Expert Services - Marshall PSP

Expert Witness Statement of Robert Swan - Drainage

Amendment C278ggee to the Geelong Planning Scheme -
Marshall PSP and DCP

25 October 2024

Figure 5 - Expected change in global mean temperature

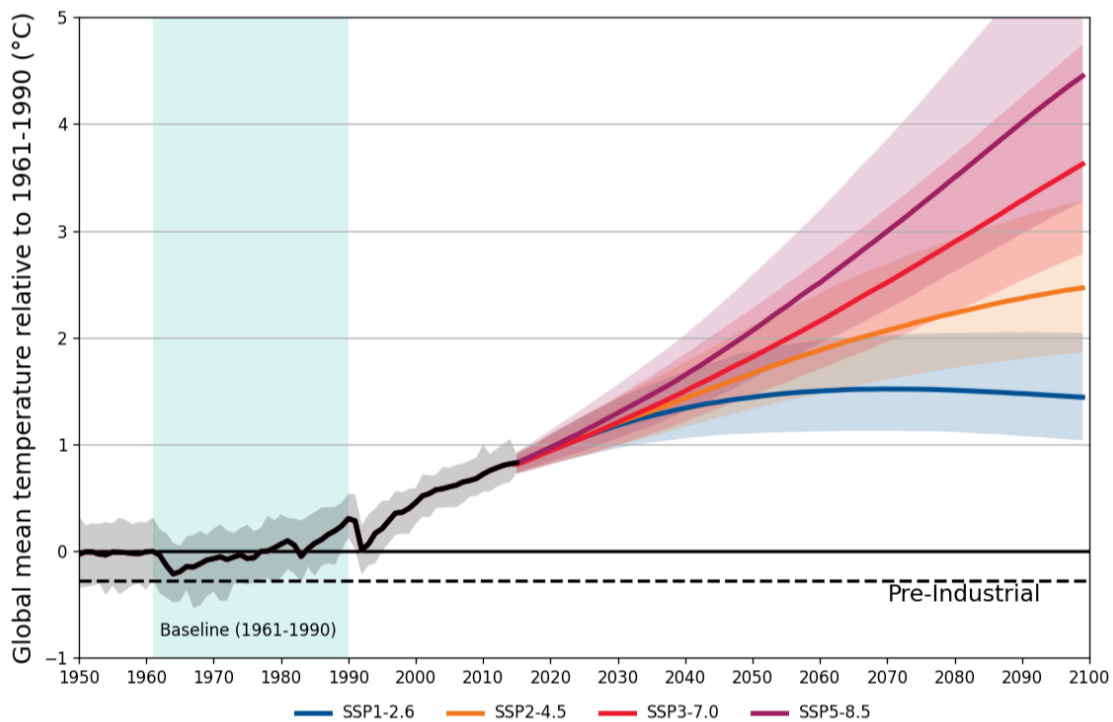
Figure 5 shows the expected increase in global mean temperature under a range of climate scenarios. A reasonable design approach may be to adopt a 2.5 degree increase above the 1990 baseline value. This would be the mid-point of the design life of the assets for the high temperature (SSP5-8.5 business as usual) pathway, but would not be reached under some lower emissions pathways. Should those pathways be achieved, then the assets would end up being overdesigned.

In the Marshall PSP it is not the case that the drainage network would fail under future climate conditions, or that it would cease to operate effectively for most rainfall events. The cost of future-proofing the system would need to be weighed against the impacts of the change. These impacts could also be managed by applying additional freeboard measures; for example, by requiring lots to be constructed 450mm above the adjacent flood levels as opposed to 300mm.

Figure 6 - Location and Catchment of SBRB2

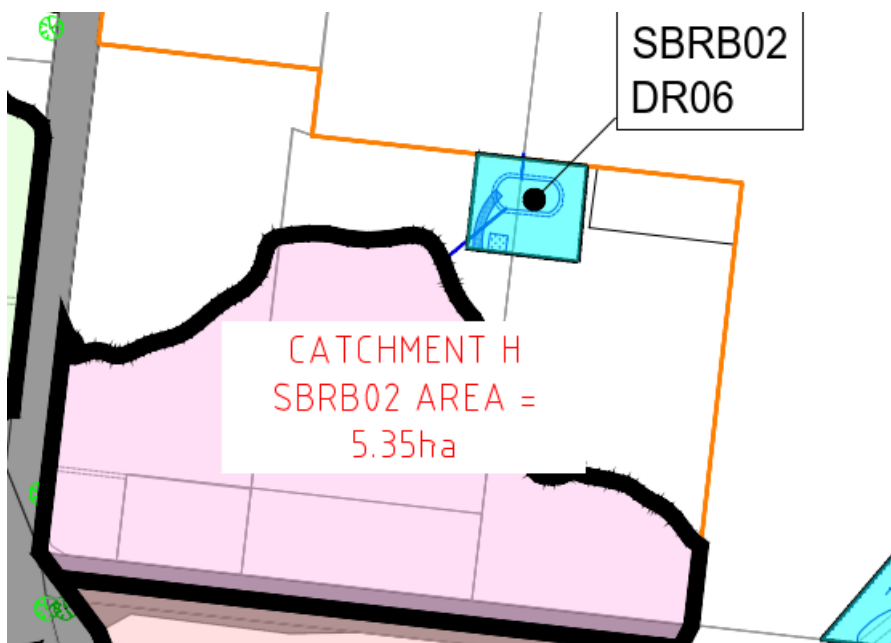
This submission is from property 40 and objects to the location of sediment basin SBRB2 as it is
380 located across two landholdings and located on existing infrastructure. The catchment area this basin is intended to service is shown in Figure 6.

385 The basin is in a location that allows connection to the swale drain running north to the Barwon
River. The basin is also within the Floodway Overlay. The submission requests that the basin
be placed wholly on the property 41 (the eastern property). The basin is only required once
development occurs on these landholdings. It may be possible for the basin to be moved fully
on the property 41, subject to detailed design considerations. I would recommend this be
390 considered by Council. It would have the benefit of fully tying the basin to the piece of land that
contributes the majority of the catchment area to its construction, provided the basin was fully
maintained within the Floodway Overlay.

- Council should consider the following amendments to the drainage works:
 - The relocation of SRBR2 to be fully on property 41
 - The provision of outfall drainage from SBRB2 to the Barwon.
